ADDENDUM NO. ONE

Villa Garza Flores Park

February 22, 2019

Villa Garza Flores Park ADDENDUM 1

Sheet MEP1.0

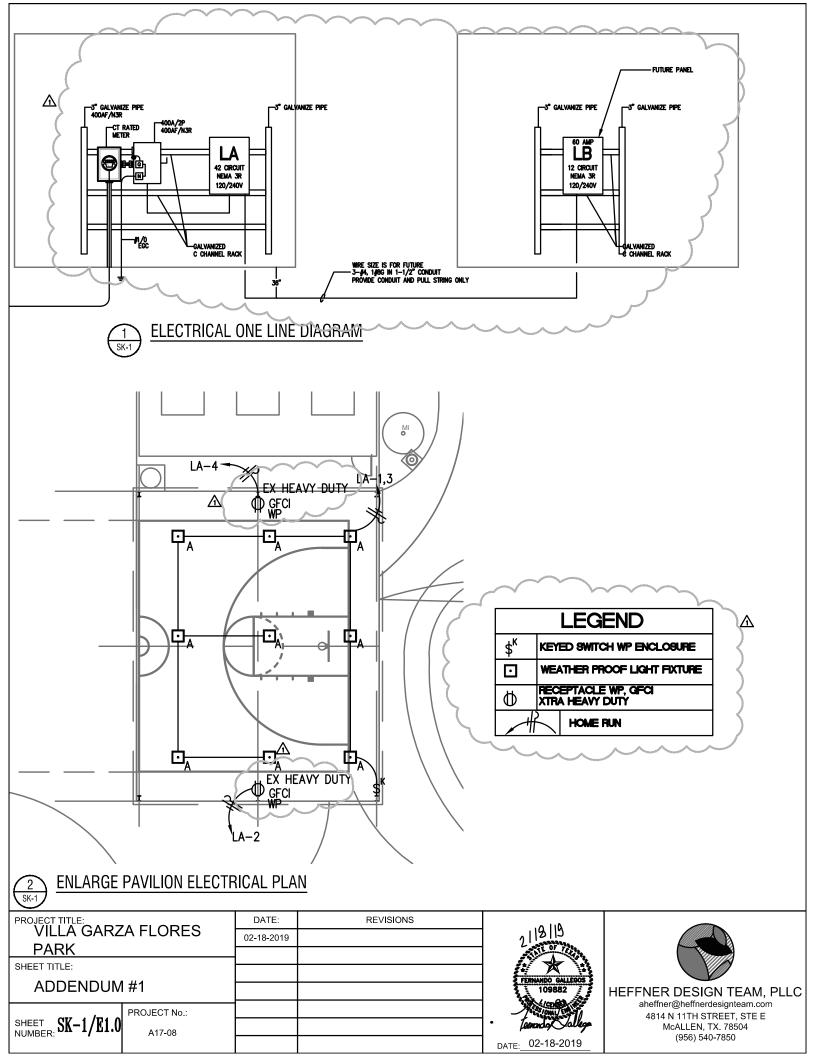
1. Added new underground line for future restroom panel refer to SK-1/MEP1.0 for details

Sheet E1.0 clarification sheet was named printed with MEP1.0

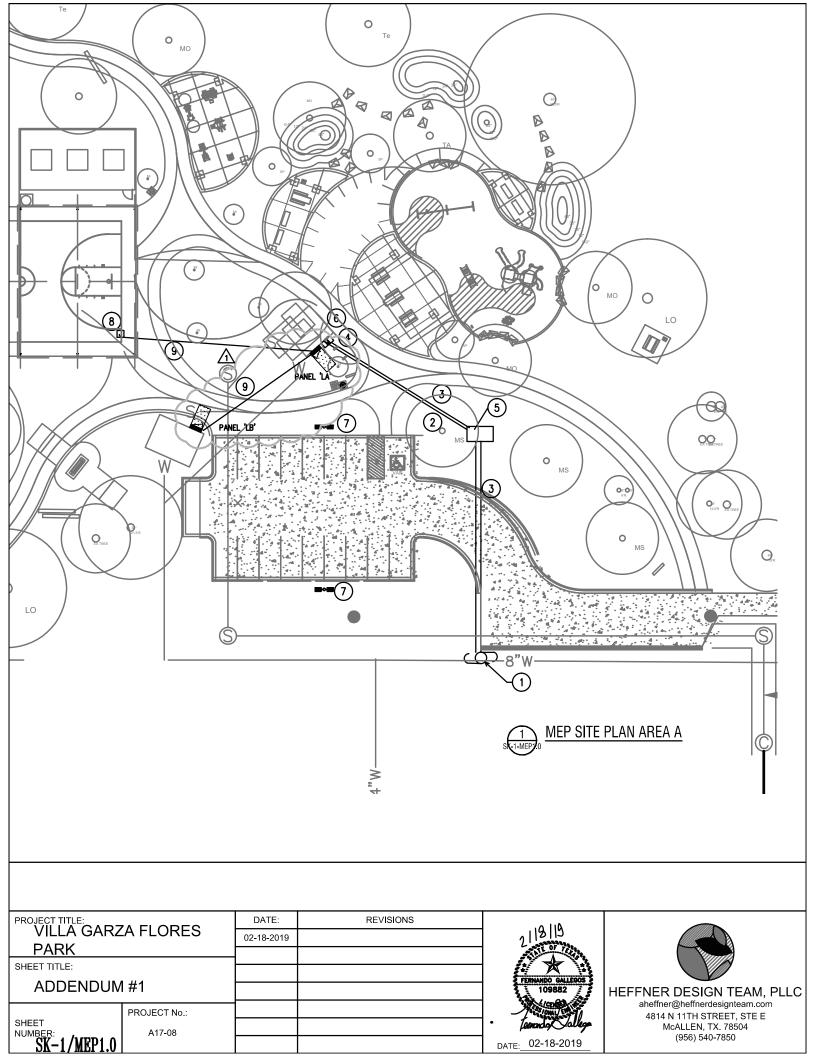
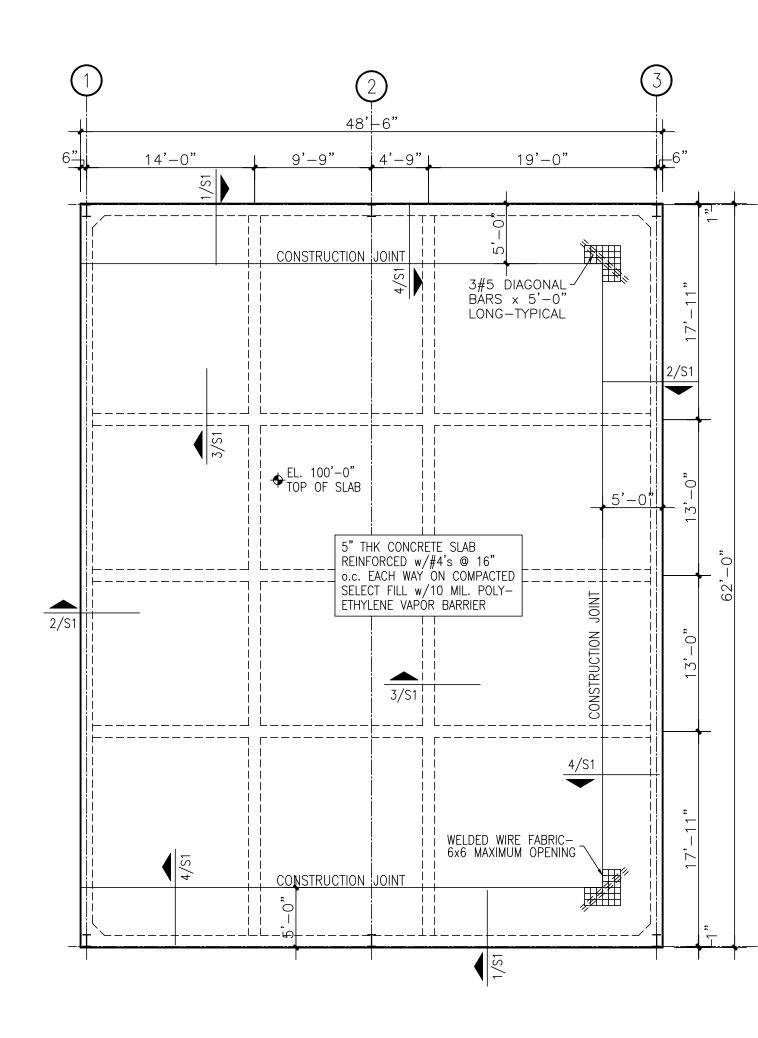
- Revised electrical one line to provide information of future restroom panel. Ref SK-1/E1.0
- 2. Added note on basketball court receptacles to be extra heavy duty weather proof and GFCI. Ref SK-1/E1.0
- 3. Added Legend to describe symbols used in pavilion. Ref SK-1/E1.0
- 4. Added 60/2 breaker on panel LA for future restroom panel.
